Item #7
MCPB
11/13/03

THE MARYLAND-NATIONAL CAPITAL PARK AND PLANNING COMMISSION
Office of the Chairman, Montgomery County Planning Board

SITE PLAN

STAFF RECOMMENDATION: Approval of 195 multifamily units inclusive of 64 MPDU's and 53 TDR's on 10.44 acres:

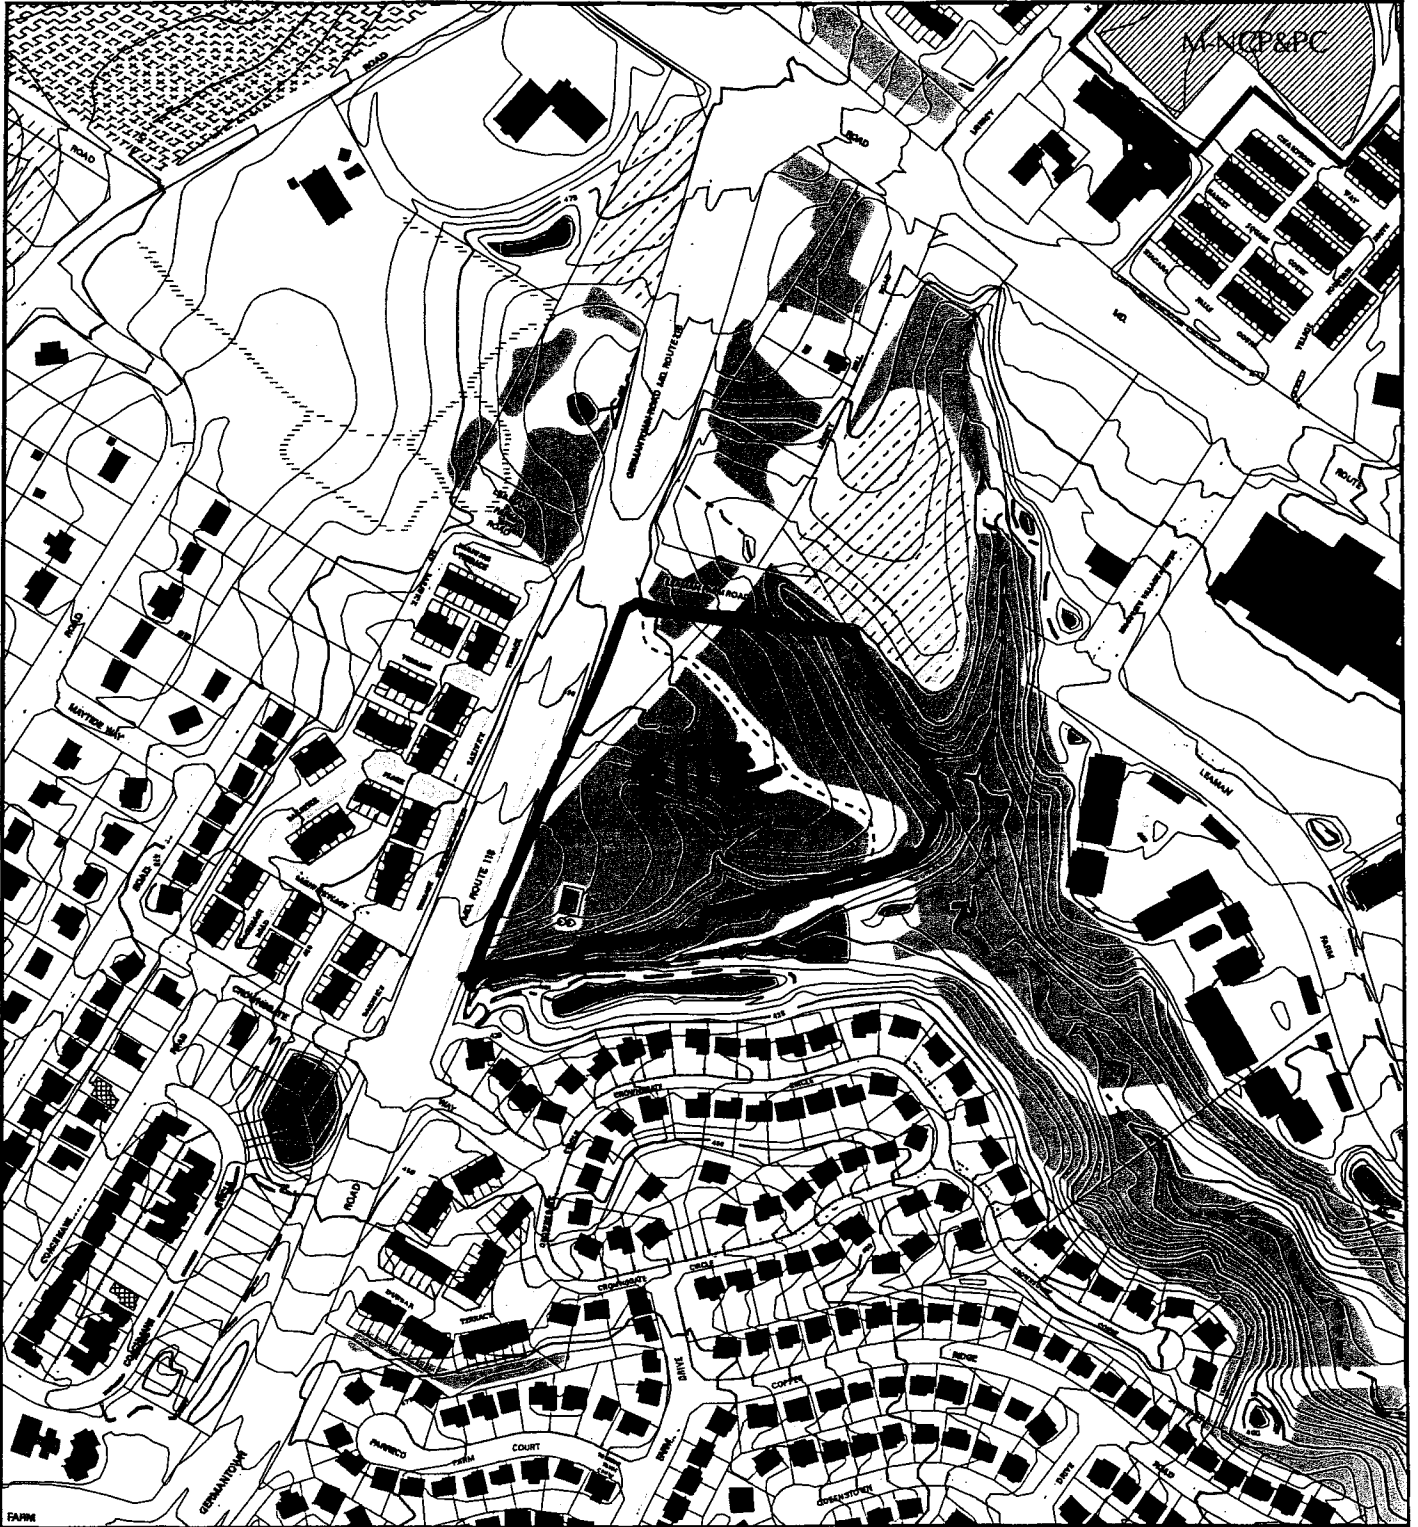
In the course of review, a letter from the community was received that requested increased screening for the parking lot along Leaman Farm Road, for a revised entrance location on MD Route 118 and increased screening for the trash compactor along MD Route 118.

Additionally, staff recommended additional sitting areas within the greenspace, sidewalk connections to the tot lot and off site, street trees adjacent the site on Leaman Farm Road and a revised sidewalk connection along MD Route 118. Landscape revisions were required to remove planting from the public utility easements and to increase visibility to the tot lot. Staff also is requesting that the sidewalk along the frontage of MD Route 118 be relocated to be inward from the curb, a safer location away from the travel lanes.

The applicant has amended the drawings to address most of the concerns. They don't want to reconstruct an existing walk along MD Route 118.

The conditions reflect staff recommendations to change the plans to increase pedestrian circulation and safety. The citizen's letter has been addressed in regards to their screening requests. The entrance location along MD Route 118 is fixed per the MDSHA review and can't be moved.
